PROJECT REVIEW COMMITTEE - CITY OF WILDWOOD
PRC Chairperson – Melanie Strickland

Agenda
Regular Meeting
June 10, 2025 10:00 AM
Commission Conference Room 124
100 N Main Street

1. **SP 2409-004 Summerfield Cottages**

2. **SP 2407-003 SoLiv at Wildwood**

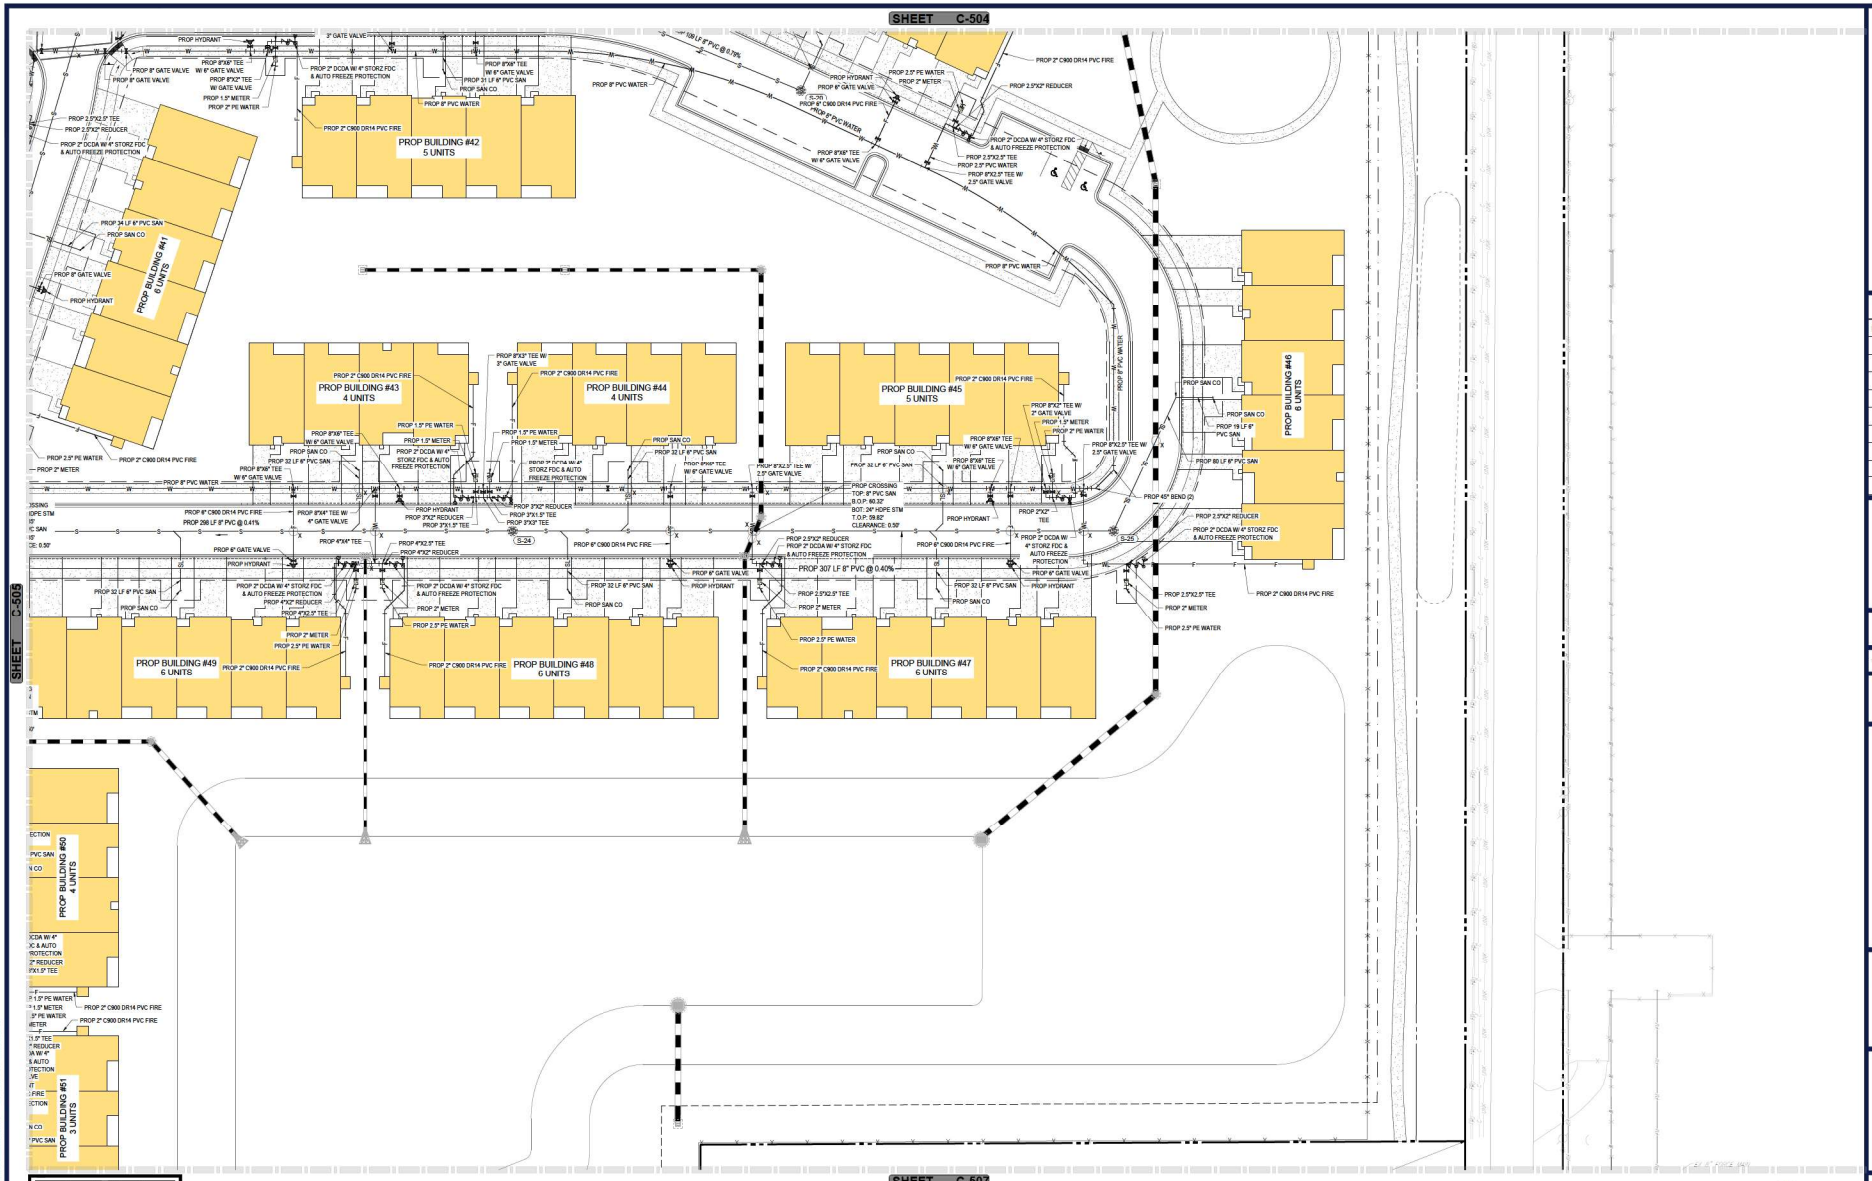
1. Sheet C-507, Utility Plan: Add 2" blowoff assemblies at all future water main stub outs. There are three total: (2) 20" and (1) 12".

SHEET TITLE:
IRRIGATION PLAN

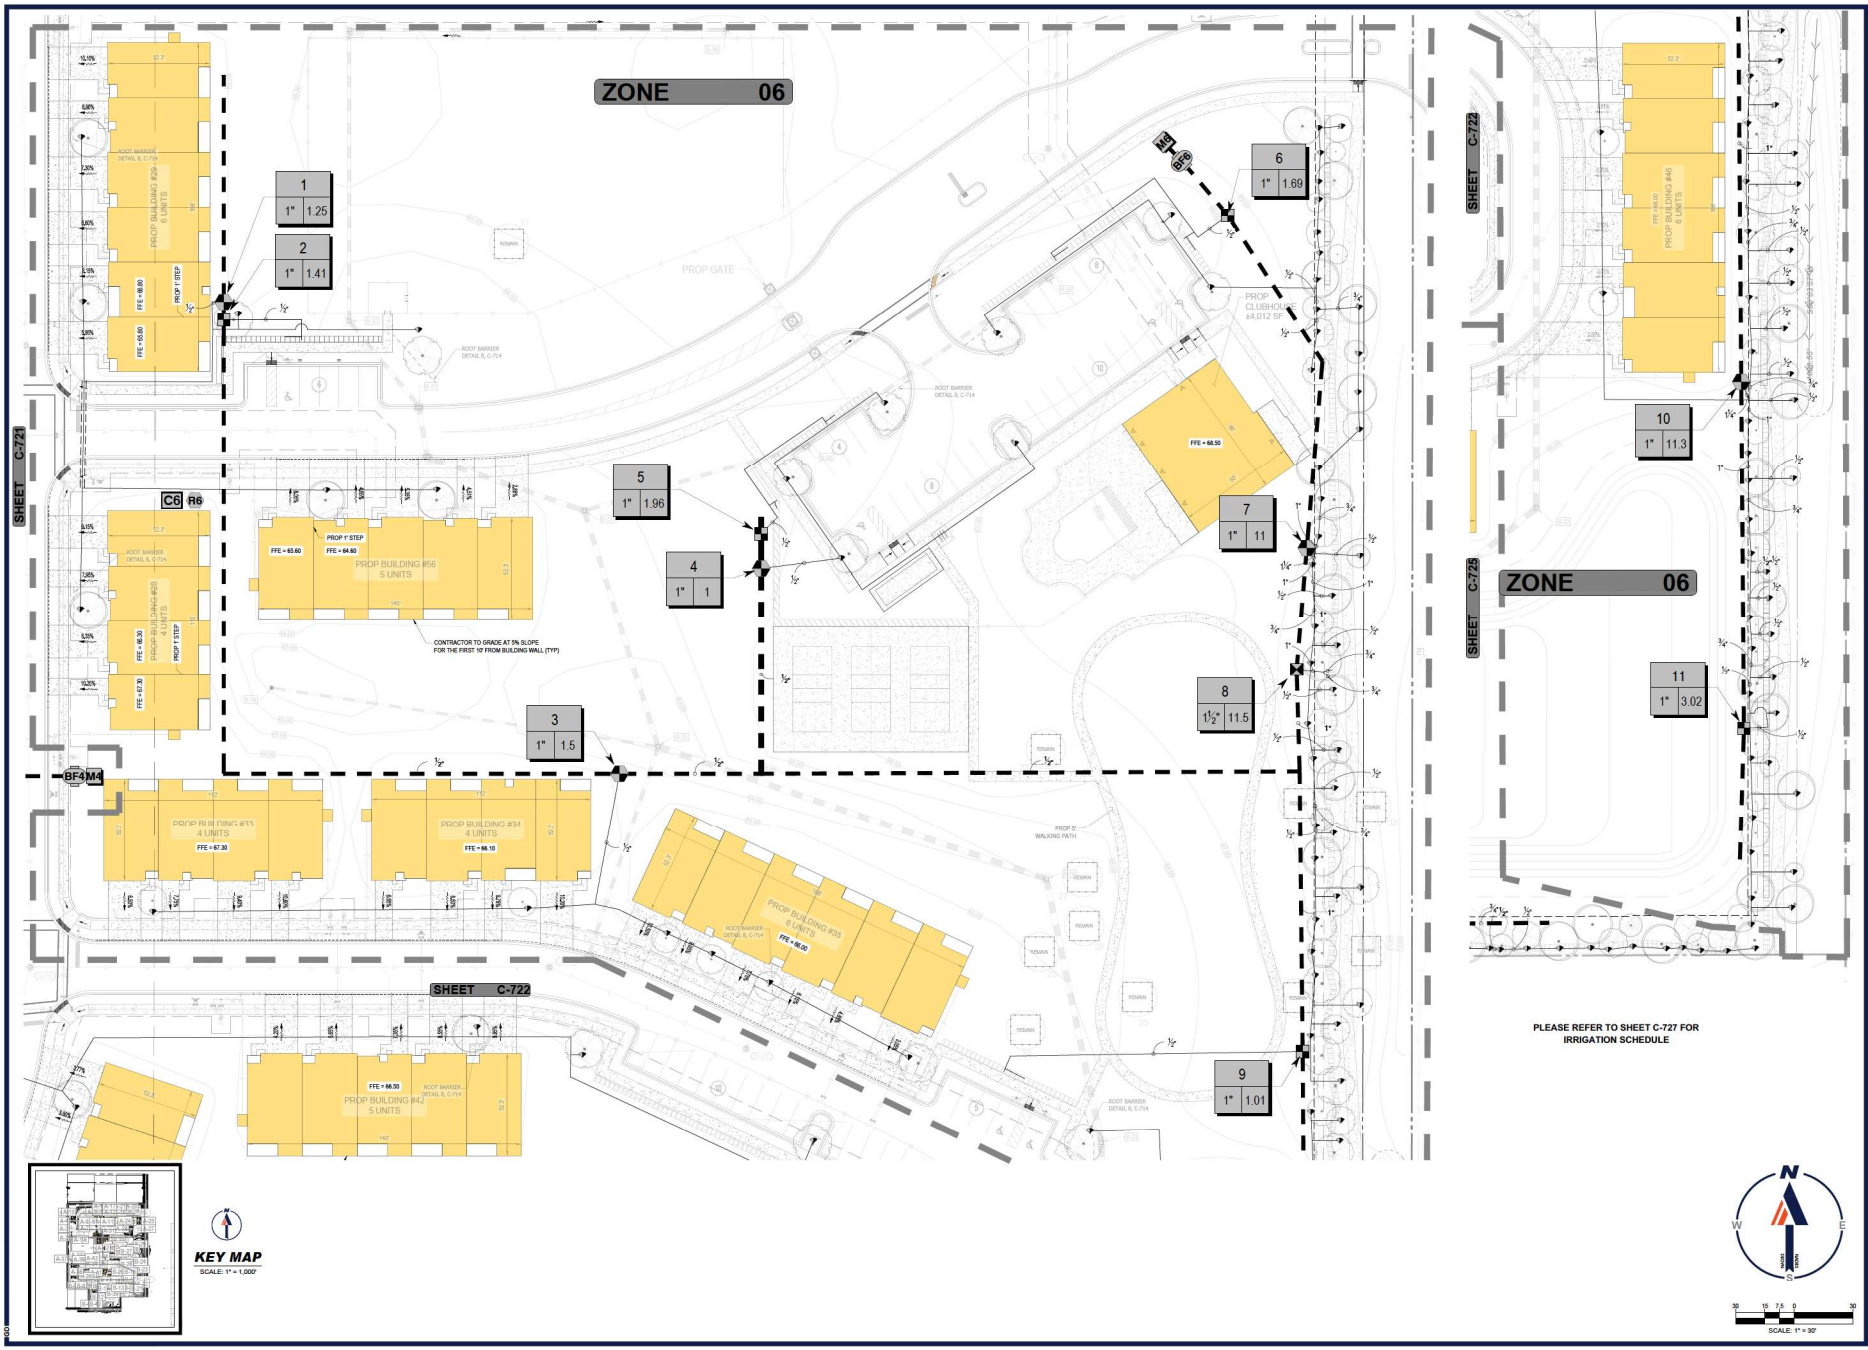
3. Sheet C-717 through C-725, Irrigation Plan: The plan sheets show and call out approximately (8) 2" irrigation meters, but the utility plan sheets have no provisions for any irrigation meters. Please show and call out all irrigation service lines and meters on the utility plans.
